Planning Committee (Smaller Applications)

Wednesday 21 January 2026
7.00 pm

Meeting Name:	Planning Committee Smaller Applications
Date:	21 January 2026
Report title:	Addendum report (adjourned planning application 24/AP/3577: LAND REAR 19-49 BUSH ROAD, LONDON SE8 5AP)
Ward(s) or groups affected:	Rotherhithe
Classification:	Open
Reason for lateness (if applicable):	N/A
From:	Director of Planning and Growth

Meeting Name:	Planning Committee (Smaller Applications)
Date:	21 January 2026
Report title:	<p>Development Management planning application: Application 22/AP/4126 for: Full Planning Application</p> <p>Address: Neighbourhood Housing Office 26 Leathermarket Street, London Southwark SE1 3HN</p> <p>Proposal: Demolition of the existing office building and associated structures and the construction of a new part 5, part 6 mixed-use building providing replacement office floorspace and 26 affordable homes.</p>
Ward(s) or groups affected:	London Bridge & West Bermondsey
Classification:	Open
Reason for lateness (if applicable):	Not Applicable
From:	Director of Planning and Growth
Application Start Date: 14.12.2022	Application Expiry Date: 08.06.2026
Earliest Decision Date: 11.11.2025

Image - Borough Open Land

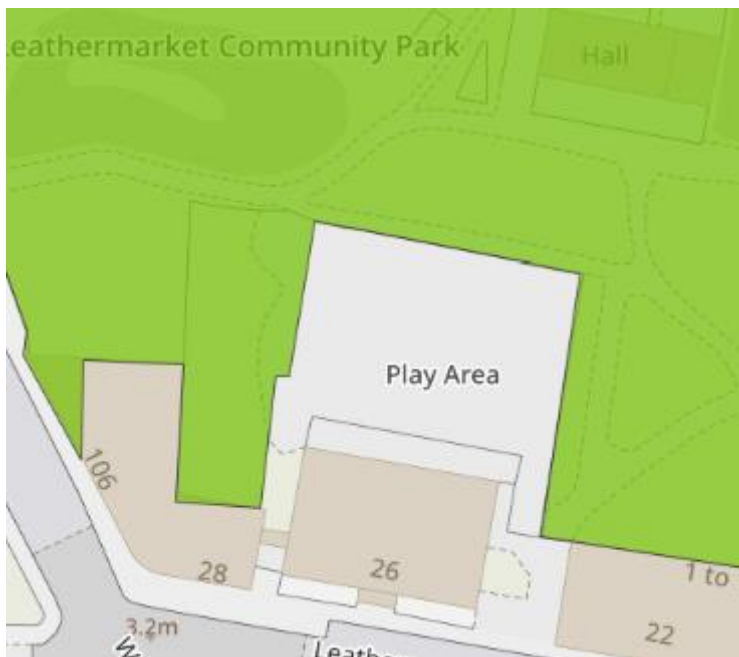
28. Objectors raised concerns that the new building would be built on land which is protected as Borough Open Land (BOL). Objectors refer to Policy P57 of the Southwark Plan which prohibits development on BOL, except in exceptional circumstances (housing is not considered exceptional). Objectors raised concern that the application's misrepresentation of site boundaries raises questions about the validity of the application.
29. The image below shows the application site is not designated as Borough Open Land.

Image - Leathermarket Gardens children's play area

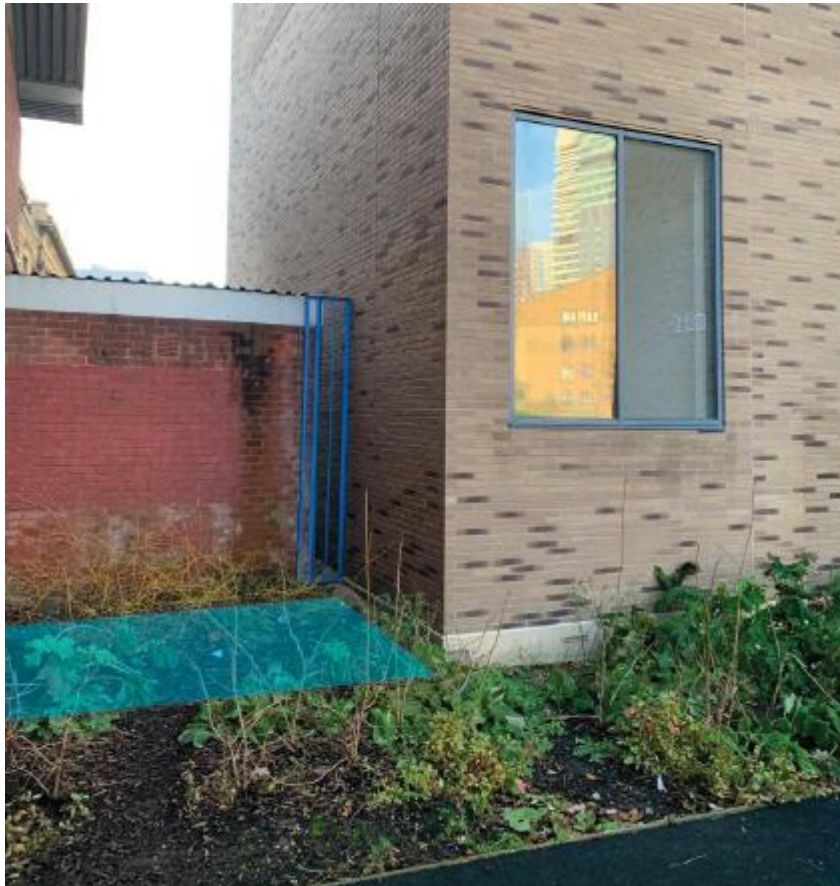
30. Objectors raised concerns that the new building would be built on land within Leathermarket Gardens children's play area. Objectors also expect to see a Play Strategy compliant with London Plan S4 and the Mayor's guidance, demonstrating inclusive, overlooked, safe play that is not compromised by the proposed development.

31. Planning officers consider that the applicant's suggestion for a small, net-beneficial adjustment to the park boundary – swapping 6.7sqm area (blue - Image – land within Leathermarket Gardens) with 15.1sqm (brown - Image – land within Leathermarket Gardens) that would increase the area under Parks' management would be acceptable as it would improve landscape quality and usability. It is noted that the Council's Parks & Natural Environment Team initially advised that their stance would be to protect parks land from development. Although the Council's Parks & Natural Environment Team appreciate the loss would be small they advised it would still be a loss. Final comments from the Council's Parks & Natural Environment Team will be reported in an addendum.

Image - Proposed Demolition South Elevation

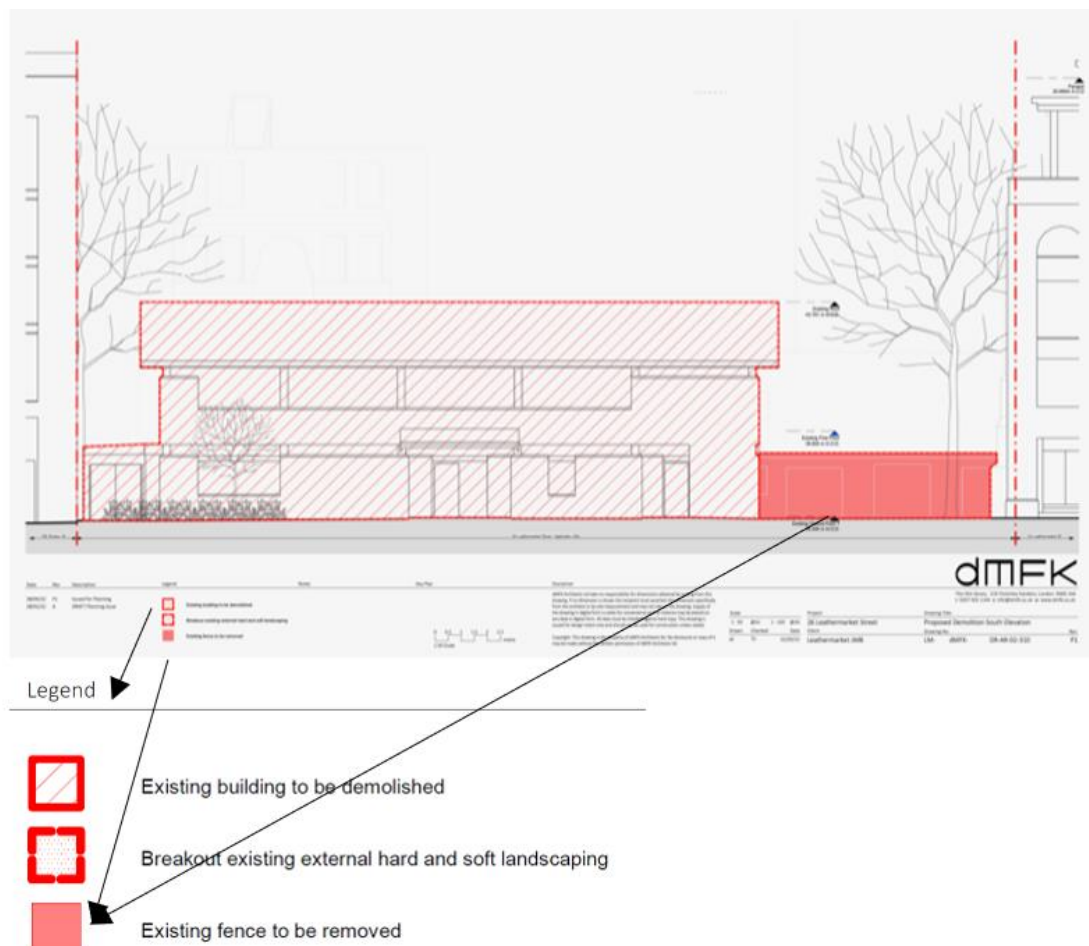
41. Objectors are concerned that the "Proposed Demolition South Elevation" drawing is misleading. The plan appears to have inserted a non-existent, flat roofed, single storey building in to the gap between 22 and 26 Leathermarket Street. There is no building, nor has there ever been a structure linking these two detached properties.'

42. The applicant responded stating 'this hatch indicates the existing metal fence which encloses the playground and entrance to the park, as noted on the legend at the bottom of the drawing 'Existing fence to be removed'.
43. As the site is within a conservation area express planning consent would be required for the demolition of the existing building. The building is not of any

Image - Site Of Importance For Nature Conservation

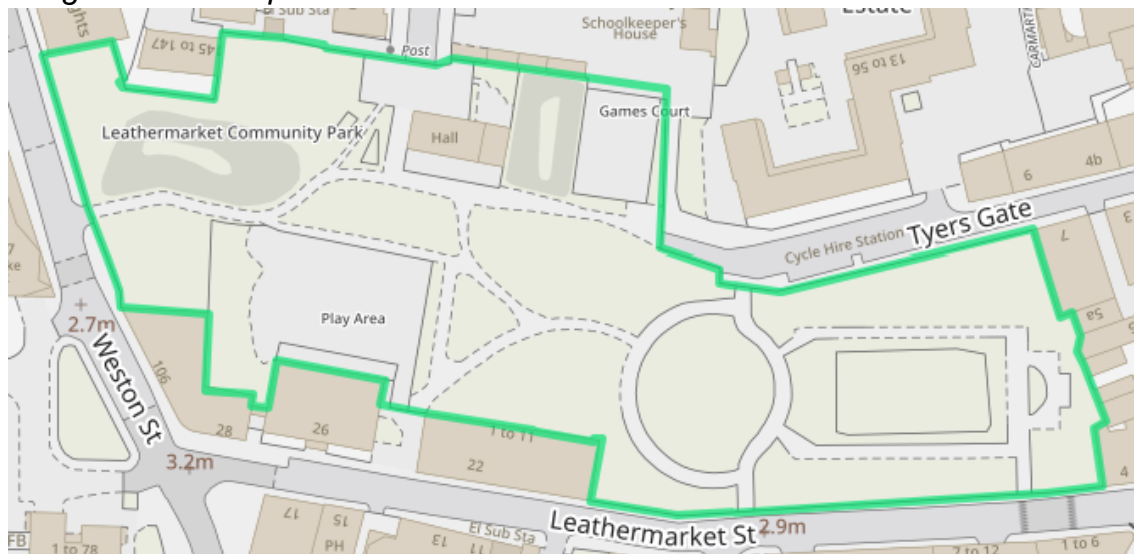
142. Objectors raised concerns that the proposed development encroaches on a planted bed within the children's play area of Leathermarket Gardens and state this area provides natural greening and visual relief, contributing to local biodiversity and ecological value.

148. The Council's Parks & Natural Environment Team are satisfied that the proposals will result in a net gain for biodiversity within the SINC boundary along the north and eastern side, where only an area of hardstanding with negligible biodiversity value will be developed with additional planting added.
149. Final comments from our Ecologist on an updated ecology survey will be reported in an addendum report.

Image – 3.8m gap to Flat 14 ,22 Leathermarket Street (rear elevation)

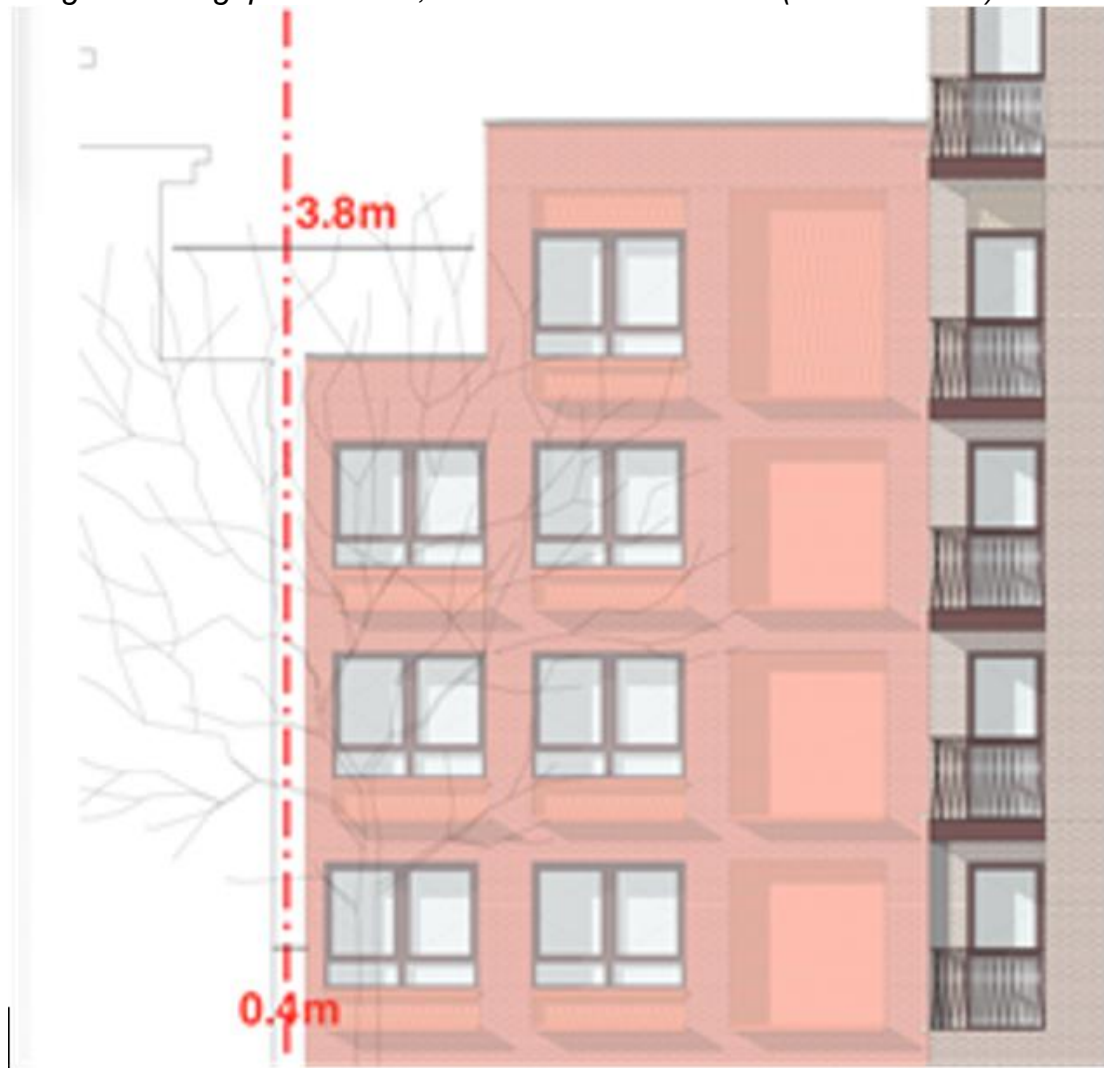
176. To further address the concern about proximity, the design was amended to increase the separation between the application site, No. 26, and No. 22 at the upper level. At the top floor of No. 22, the distance to the proposed building at No. 26 has been increased to around 3.8 metres by creating a stepped cut-out in the design. Previously, this distance was 1.4 metres. At the lower levels, the buildings remain party wall to party wall with a gap of approximately 0.4 metres (400mm). The increased upper-level separation creates an open, naturally ventilated gap and removes any suggestion of heat transfer or restricted airflow between the two buildings.

Image – fire exit 22 Leathermarket Street and visualisation of the proposed undercroft area

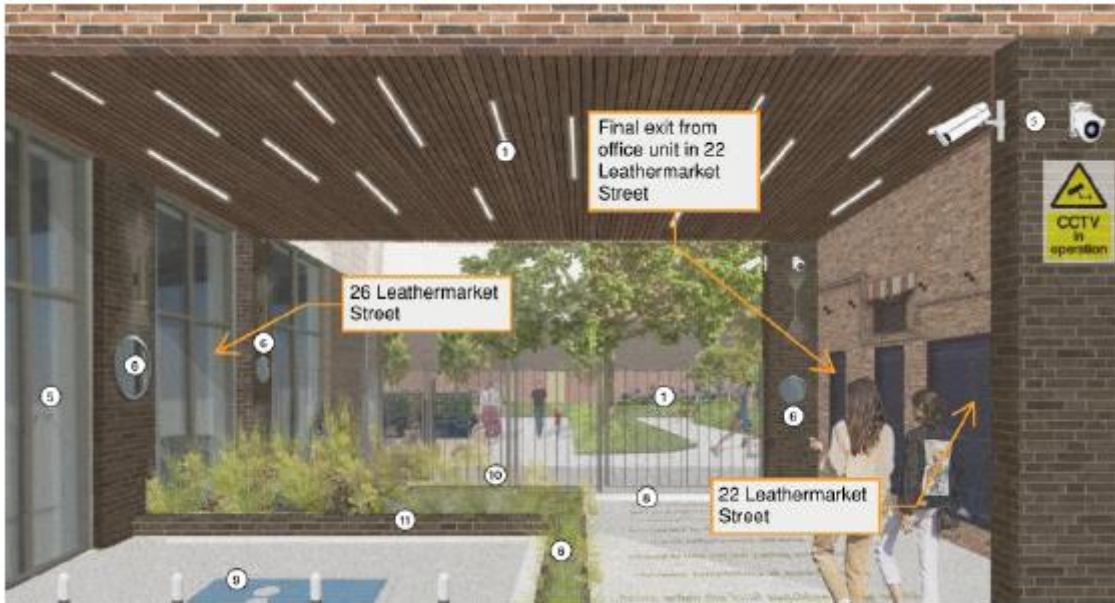
193. Objectors also raised concerns that *'during construction, the escape route' of 22 Leathermarket Street 'would be unusable; in the completed scheme, it may be enclosed, obstructed, and fundamentally altered. At every stage — excavation, piling, and construction — safe egress would be impossible.'*

Image – inaccessible green roof

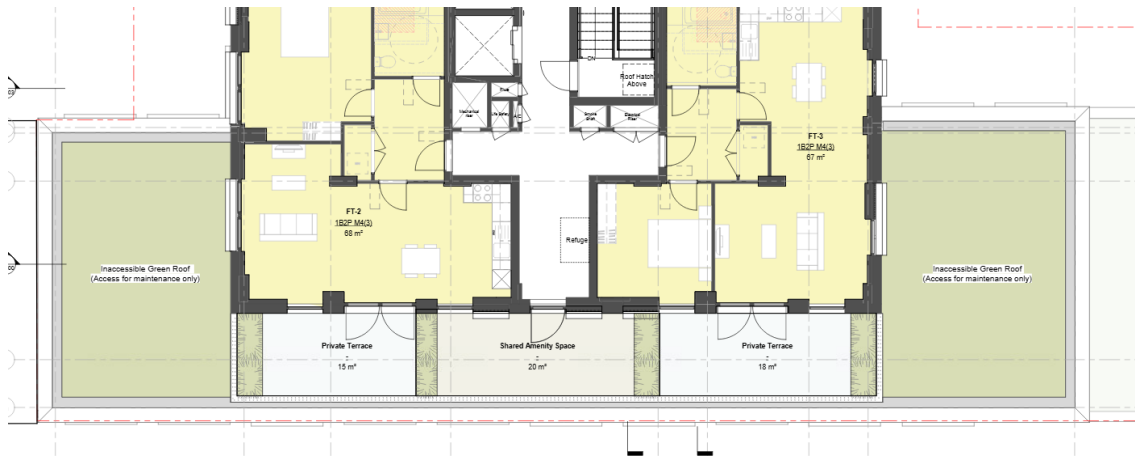
211. To the south of the site, the existing properties across the road would be situated approximately 10m from the proposed development. Due to the narrow street and pattern of development in the vicinity of the site this would be a similar distance to the separation from number 22. The second floor of the public house, The Leather Exchange, at number 15 is in residential use.
212. Objectors are concerned that future residents would have access to the proposed green roofs and that this would infringe on the privacy of the neighbours.

213. The applicant responded stating that the ‘green roof would provide ‘access for maintenance only’’. This is achieved with a 1.1m high balustrade. This is from a private external demise which is not communally accessible. This communally accessible terrace is also separated by a metal balustrade to prevent access onto the private balconies. There are multiple points of access control with data logging from the street, through communal gates, from the primary access doors and lobby doors before this terrace can be accessed. These areas will also be covered by CCTV which will be signposted as a deterrent. These measures significantly limit the access of people from street to the communal terrace and the risk of tailgating. The private terraces themselves are accessible to the owners of these apartments only. This has been reviewed by the Secure By Design Officer prior to submission who have not raised any issues. The Met police have also reviewed the plans during the statutory consultation process and have not raised an objection.’
